UNITED STATES ARMY ARMOR BOARD
Fort Knox, Kentucky

SUBJECT: Report of USATECOM Project No LF-3216-42, Evaluation of
Computer, Ballistic, M13A1D, with Improved Illumination
for M60 Series Tanks

SUBJECT: Report of USATECOM Project No 1F-3216-42, Evaluation
of Computer, Ballistic, M13A1D, with Improved Illumination
for M60 Series Tanks

COMPUTER, BALLISTIC, M13AID, WITH IMPROVED ILLUMINATION

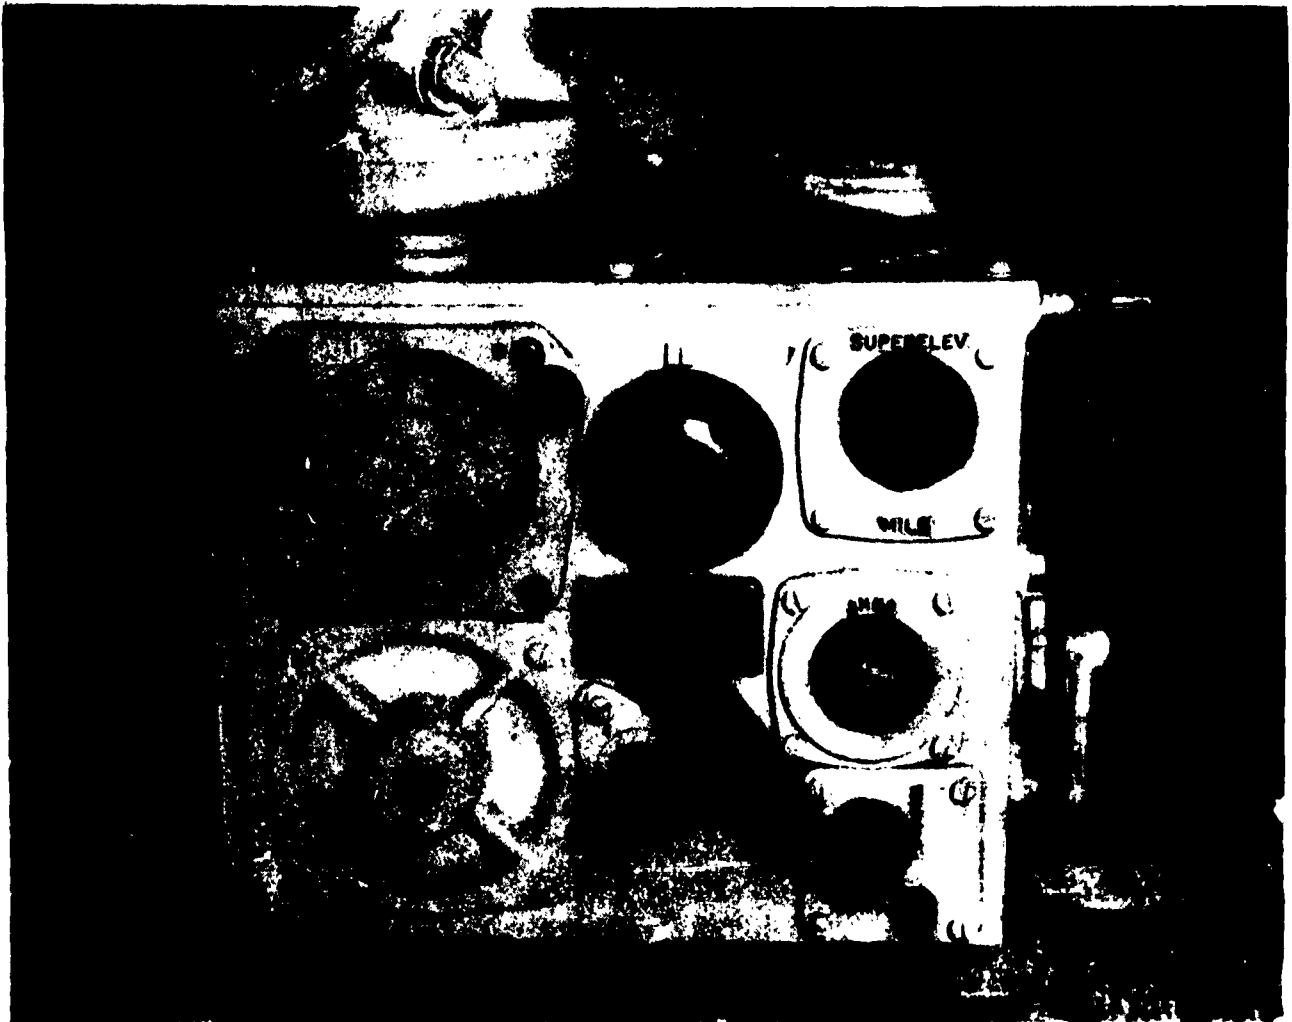
a. Range Dial Illumination. The white concentric rings with black strips surrounding the index marks reflected sufficient light to provide adequate illumination for both the range scale and the index marks.

b. Light Intensity. A single rheostat controls the intensity of all illuminating bulbs in the computer. When light intensity is set at the desirable level for reading the range dial, light omitted from the ammunition index tab window is excessive. This fault is considered a shortcoming.

c. Ammunition Selector Handle. The size and configuration of the folding ammunition selector handle are acceptable. Improvement of the handle by enlarging it is precluded by the location of the reset button indicator light.

a. The condition whereby proper illumination of the range dial results in excessive light from the ammunition index tab window was reported in reference 2d and not corrected in the present test item.

a. The remodified M13A1D ballistic computer be further modified, if practical, to correct the shortcoming noted in paragraph 5b.
